**AMENDMENT TO THE
PRELIMINARY DRAINAGE REPORT
for
WINDERMERE**

Engineering Review

**EPC Planning & Community
Development Department**

**Cursory comments. See
comment letter also.**

WINDERMERE
PRELIMINARY PLAN
N. MARKSHEFFEL ROAD
EL PASO COUNTY, COLORADO

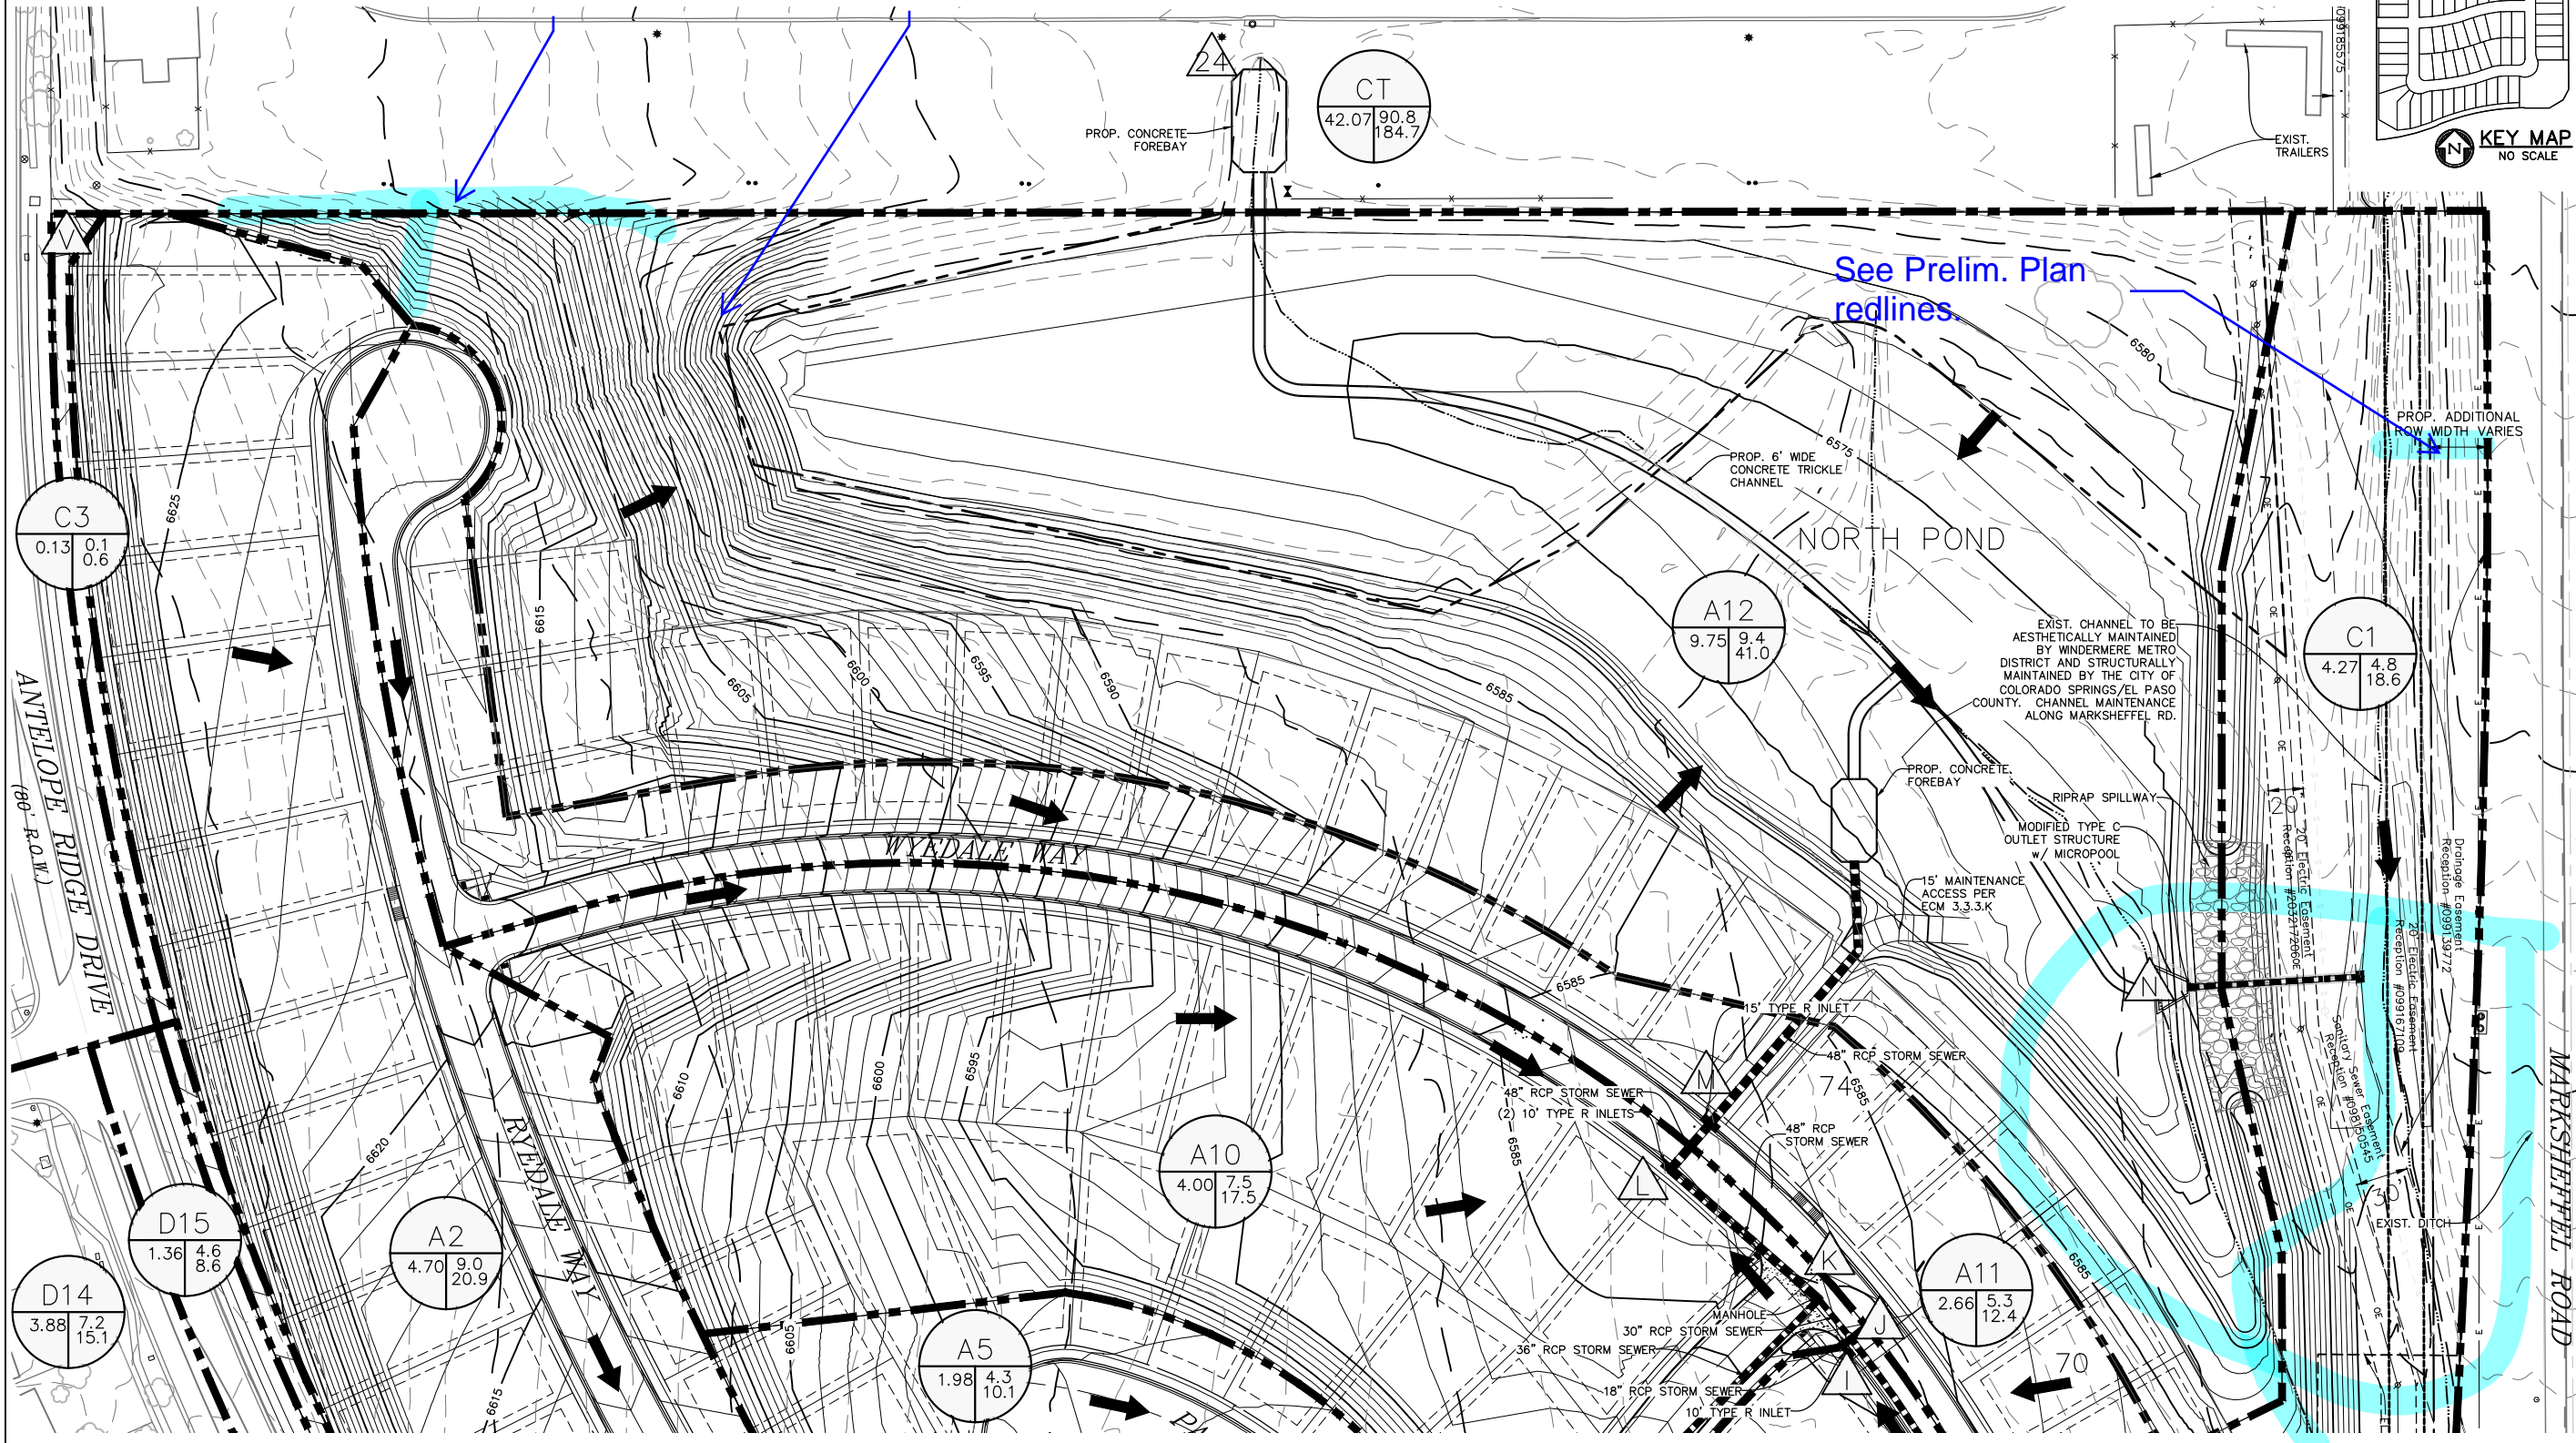
Offsite swale with easement?
Provide stabilized rundown

See Prelim. Plan redlines
